PROJECT NUMBER: SP2023-030  
PROJECT NAME: Site Plan for Clay Cooley  
SITE ADDRESS/LOCATIONS: 1540 E INTERSTATE 30

CASE CAPTION: Discuss and consider a request by Lynn Rowland of Claymoore Engineering on behalf of Clay Cooley of 1540 East IH-30 Rockwall, LLC for the approval of a Site Plan for the expansion of an existing Motor Vehicle Dealership (i.e. Clay Cooley Hyundai) being a 7.17-acre tract of land identified as Lot 2, Block 1, Rockwall Recreation Addition, City of Rockwall, Rockwall County, Texas, zoned Light Industrial (LI) District, situated within the IH-30 Overlay (IH-30 OV) District, addressed as 1540 E. IH-30, and take any action necessary.

DEPARTMENT	REVIEWER	DATE OF REVIEW	STATUS OF PROJECT
PLANNING	Henry Lee	08/25/2023	Needs Review

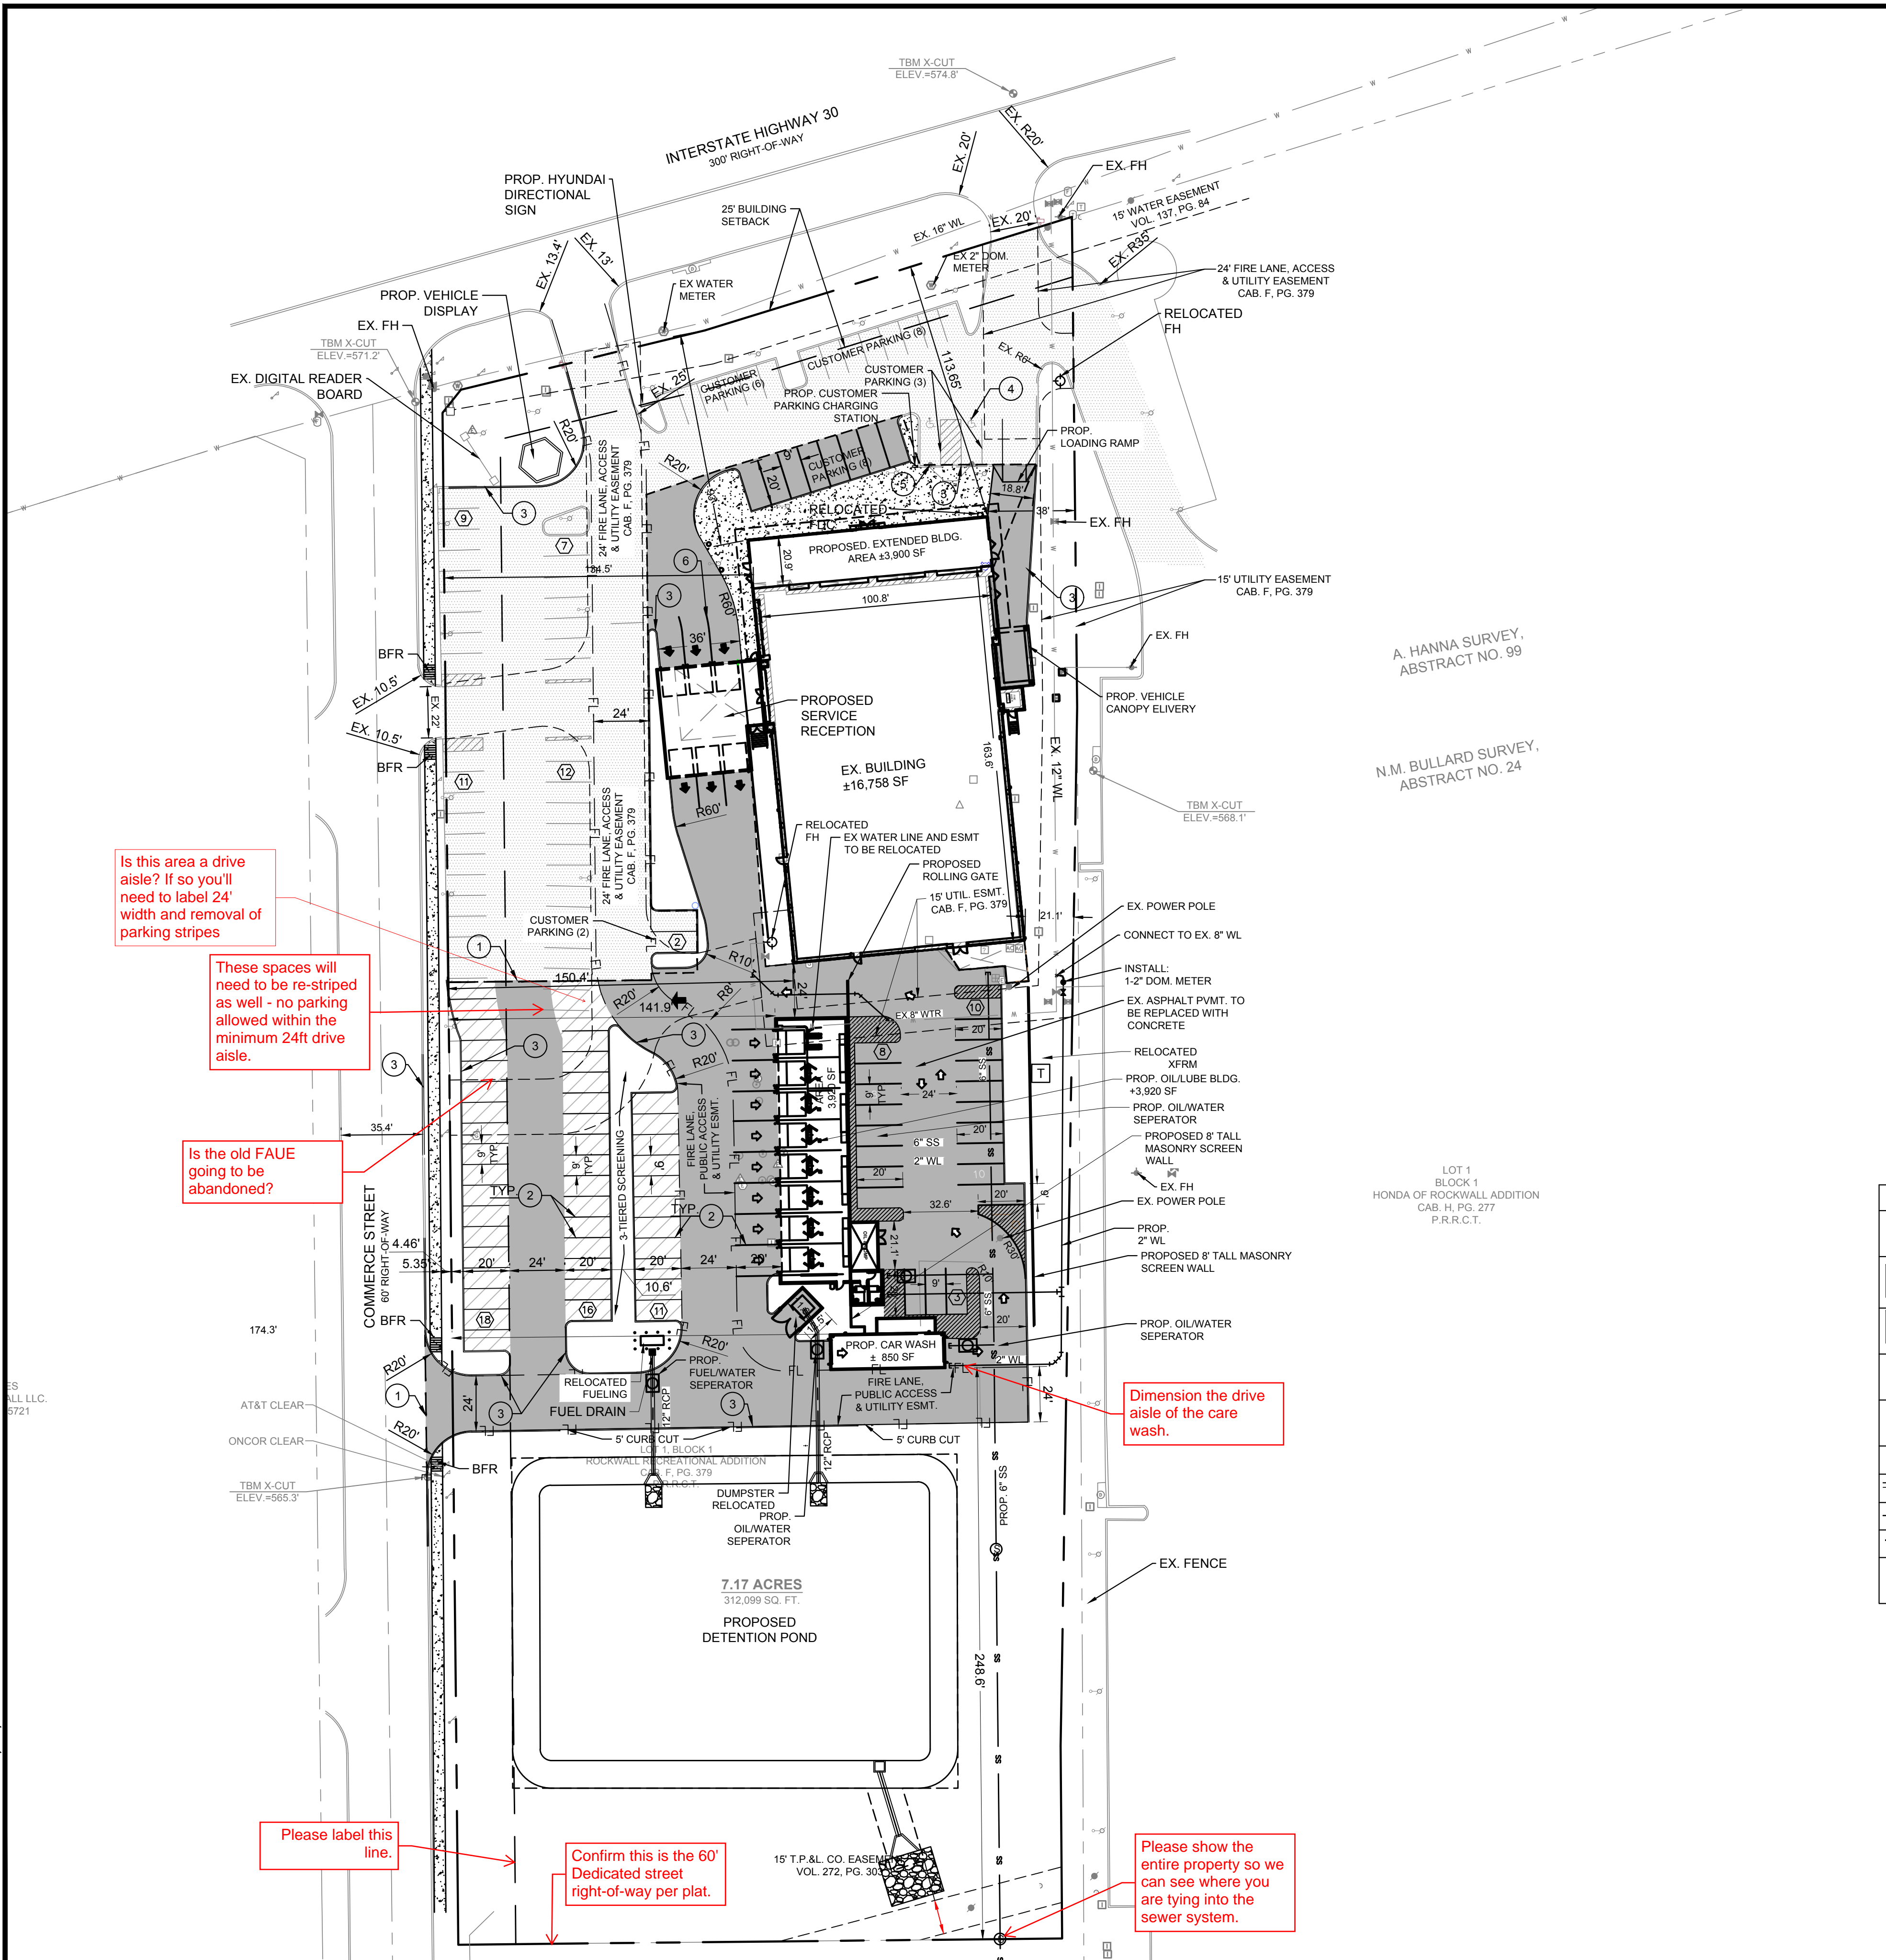
08/21/2023: 1. All parking spaces must be within 80' of a tree canopy

2. All parking along Commerce Street and I-30 must have a headlight glare screen which is evergreen shrubs 24" tall at time of planting that are planted 36" on center.
